IREDELL COUNTY HEALTH DEPARTMENT

IMPROVEMENT PERMIT / AUTHORIZATION TO CONSTRUCT / OPERATION PERMIT / EXISTING SYSTEM INSPECTION

PERMIT# 71792 PIN# ~~4625944168447 (Tim Helms const)~~ 4635-12-9274 DATE 5/19/00

SUBDIVISION POINTE BLOCK / SECTION 1A LOT 87 LOT AREA 44,270ft² SITE CLASS. PS DESIGN FLOW ~~600~~ 600gal. T.A.R. .25gal/ft²

AS BUILT SKETCH

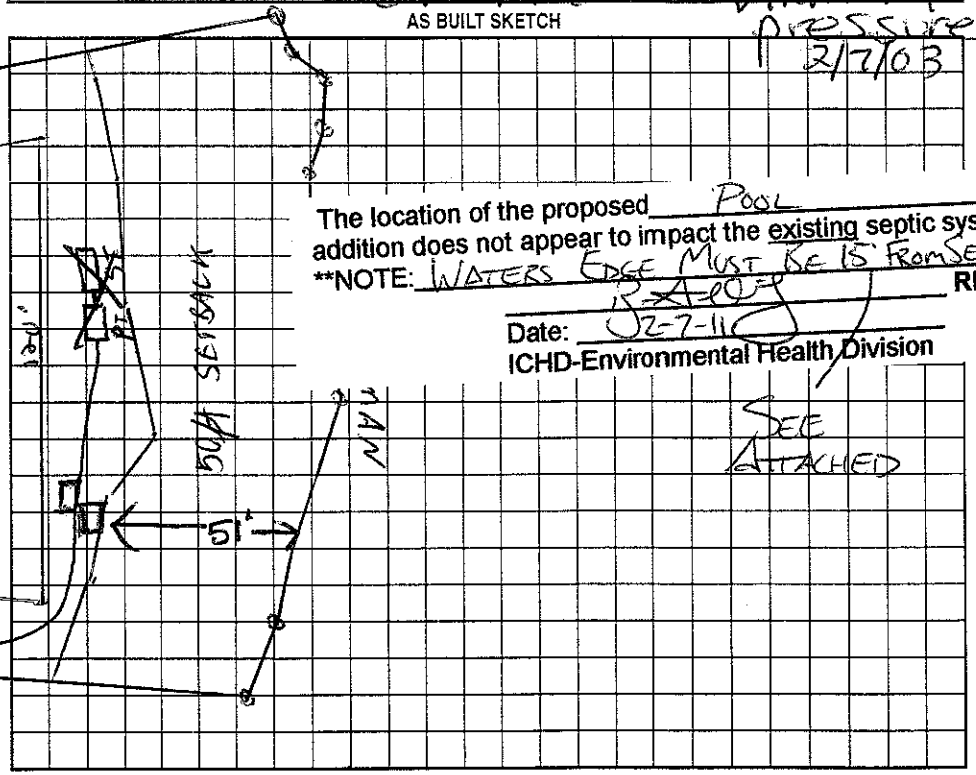
Comments:/Conditions: Installed Panel lines as drawn Cover a little, shallow, must have 6" when backfilled. Checked Elect, Alarm & Pressure 2/7/03

The location of the proposed Pool addition does not appear to impact the existing septic syster
**NOTE: Waters Edge Must Be 15' From Septic
REHS
Date: 12-7-11
ICHD-Environmental Health Division
